Subject: November 2010 Inspection Report, Cameco Resources, Permits 603 & 633

NOVEMBER 2010 INSPECTION REPORT DISTRICT 1/LAND QUALITY DIVISION

COMPANY: Cameco Resources (CR), Highland Ranch, Permit #603
& Smith Ranch, Permit 633

Figure 1 power line installation at SHRUP #9

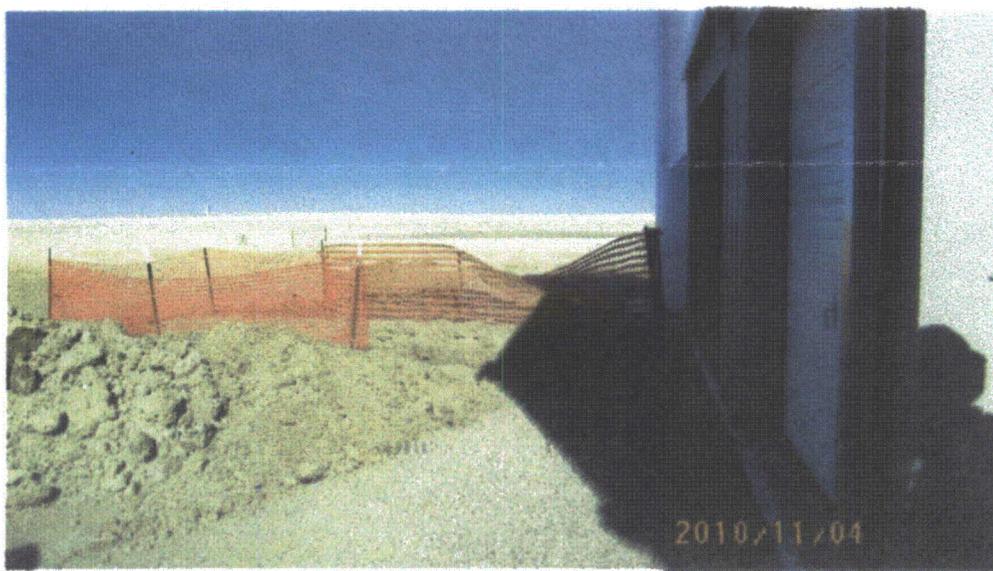
- **Inspection of SHRUP #9** – disturbance was recently seeded and mulched; crimper is not working as well as desired, CR may purchase additional crimping equipment. Work crew was working on general surface and building work to complete backfill following power and pipeline installations (Figure 1). The disposal well will be used in part for disposal of waste water from MUs D and E; waiting on approval from WDEQ/WQD

Figure 2 Reclaimed wellpad SRHUP #10

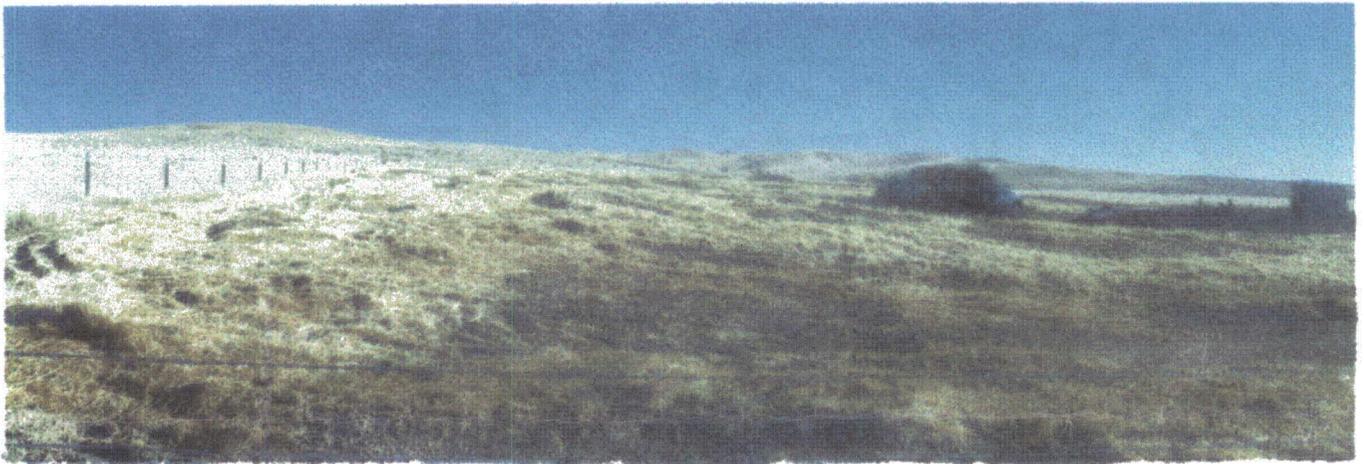
Inspection of SHRUP #10 – waiting on power installation; surface reclamation in progress (Figure 2); also conducting some road work for the landowner. The disposal well will be used in part for the disposal of waste water from MU-4; waiting on approval from WDEQ/WQD. The sediment that was located outside the disturbance noted during the September inspection was removed and the surface reseeded. A topsoil stockpile remains on the location (Figure 3). A connecting road has been improved from the DDW site to Satellite No. 1.
